# CITY PLAN COMMISSION STAFF REPORT

October 18, 2022

**Project Name**  
The Depot on Old Santa Fe

**Request**  
CD-CPC-2022-00161  
Rezoning to UR/MPD  
(Residential Development Plan) &  
Preliminary Plat

**PRELIMINARY PLAT**

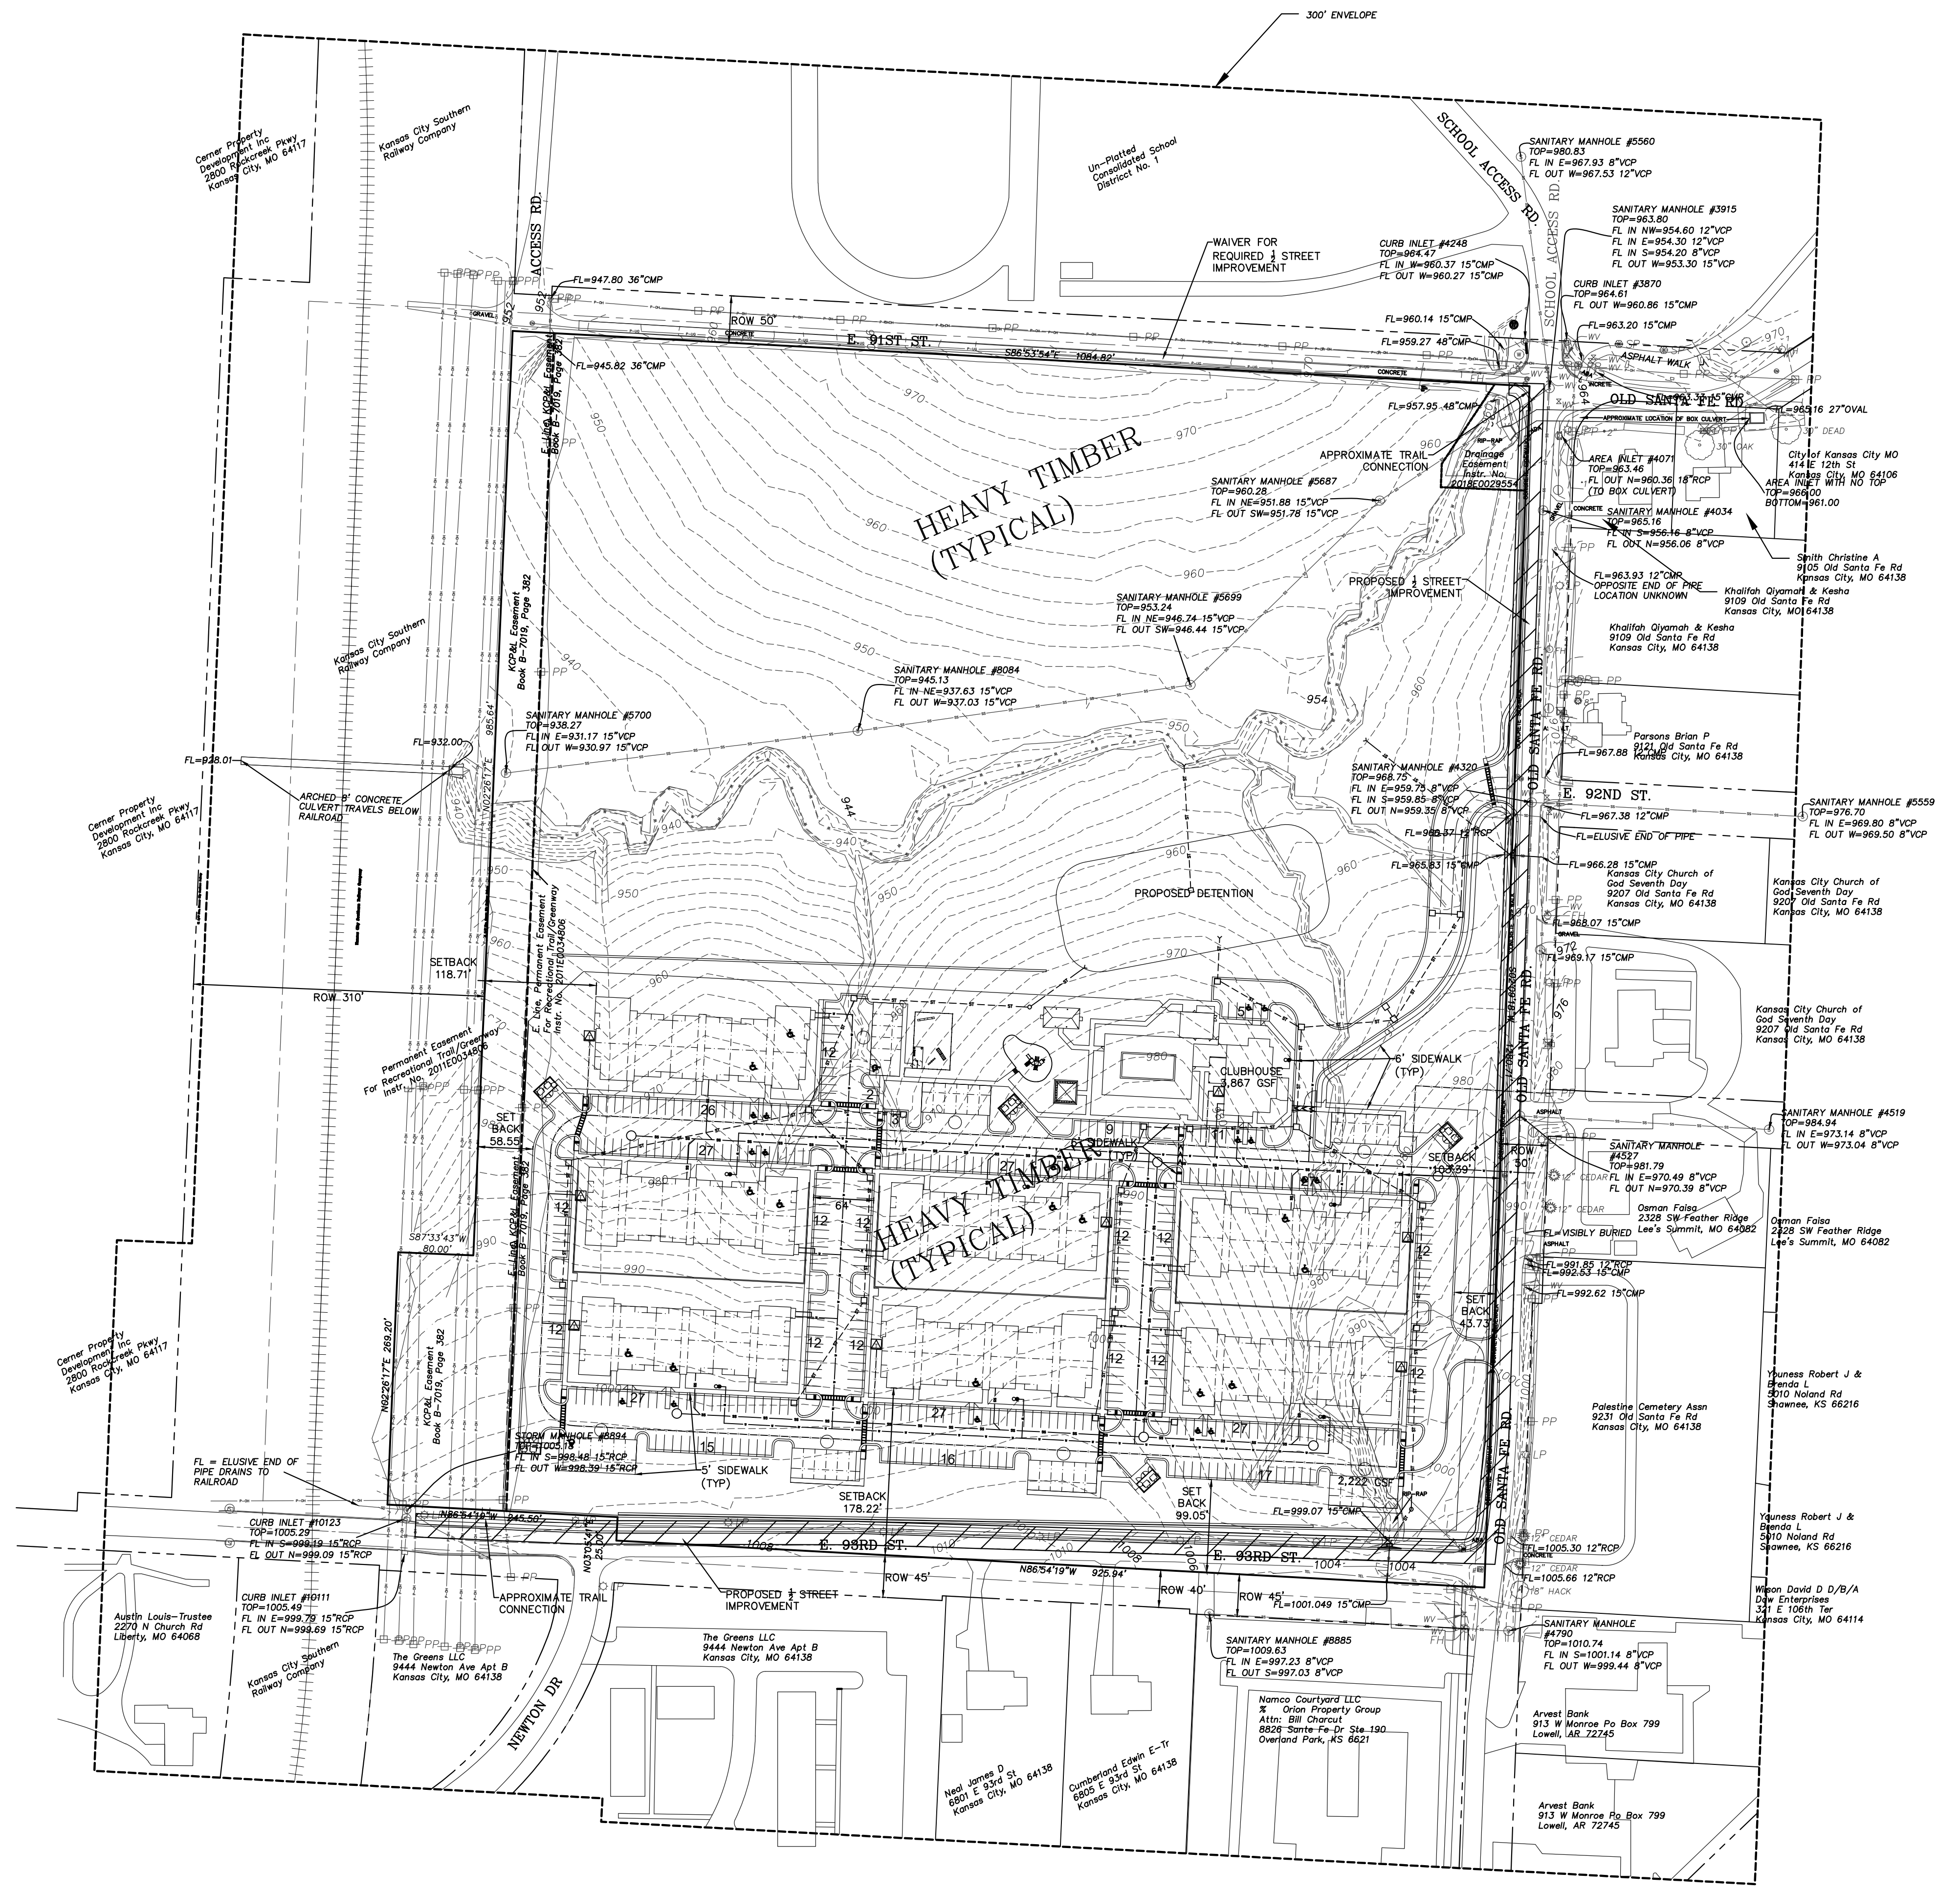
11. The developer shall include fence material and height on revised landscape plan before receiving any building permit.
12. The developer shall seek a waiver, to be listed on the preliminary plat sheet to section 88-405-10-K - Half Streets.

**OVERALL  
LANDSCAPE  
PLAN**

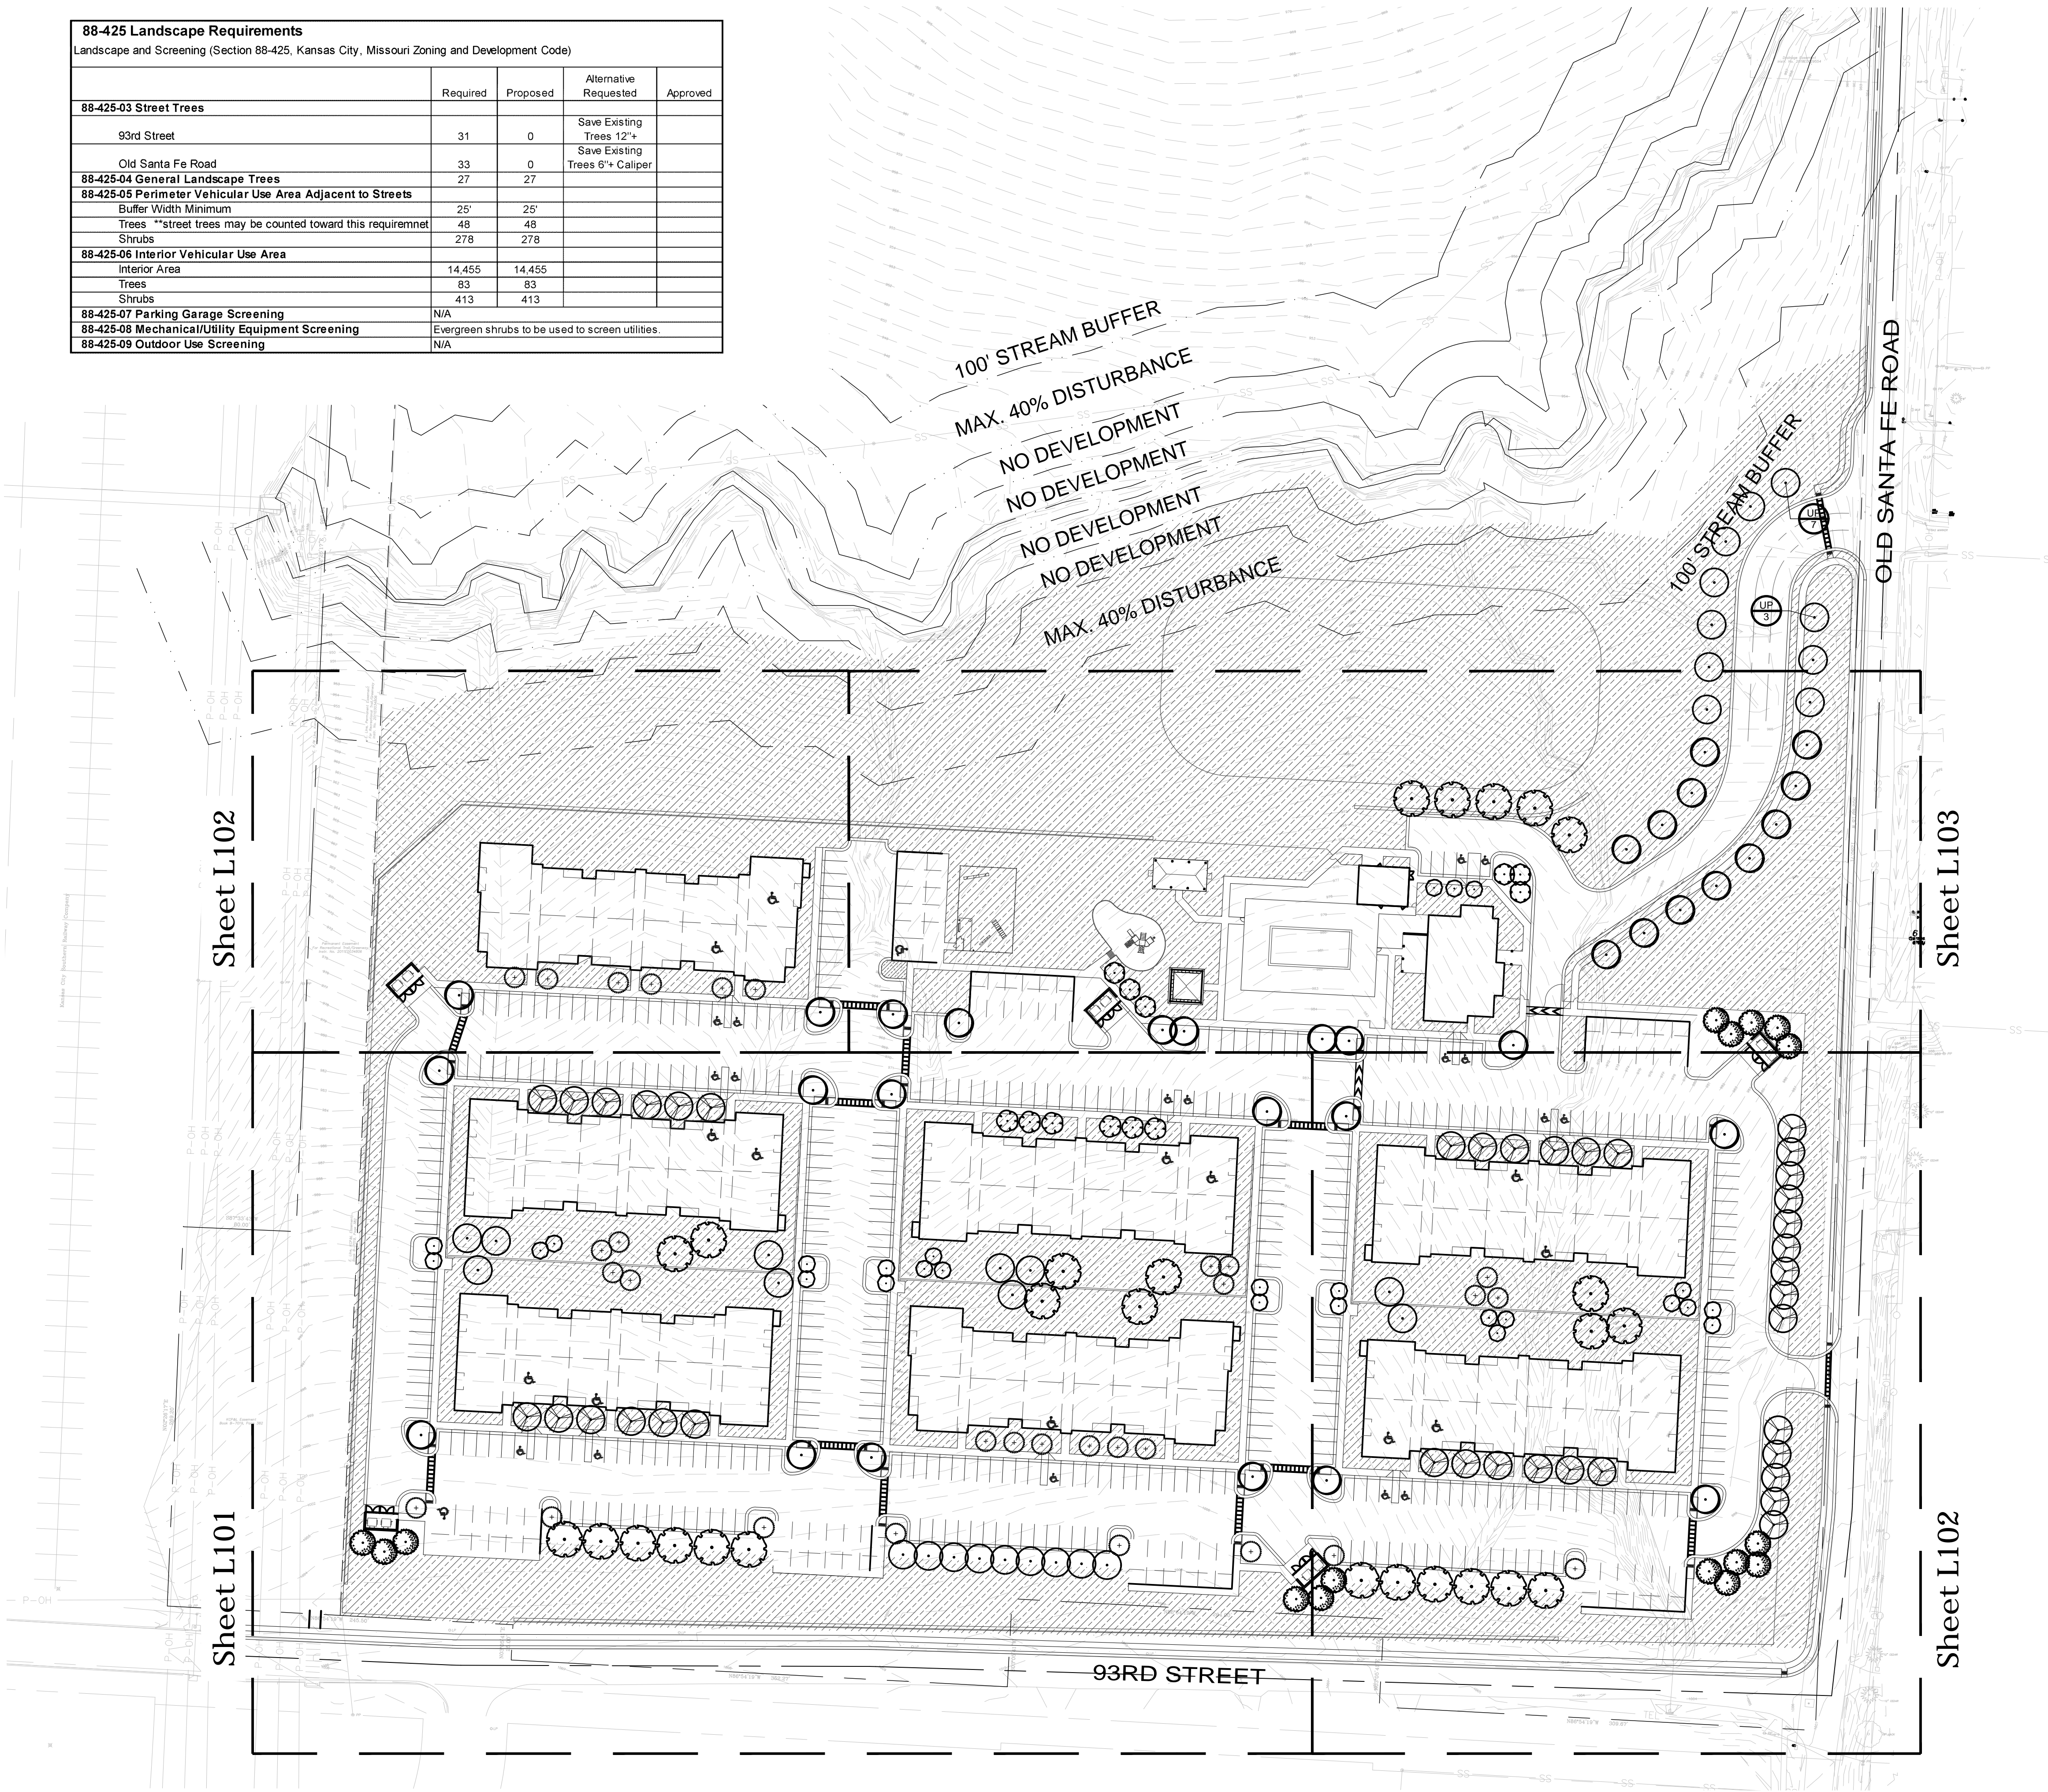
The applicant has proposed to preserve 45% of the existing trees located on this property. The applicants plan also states that the owners intend to "save and protect all existing mature and healthy trees 12" + caliper along E. 93<sup>rd</sup> Street." and "save and protect all existing mature and healthy trees 6" + caliper along Old Santa Fe Road." Staff applauds the applicant for taking this section of the Code seriously and working diligently to provide a meaningful tree removal plan.
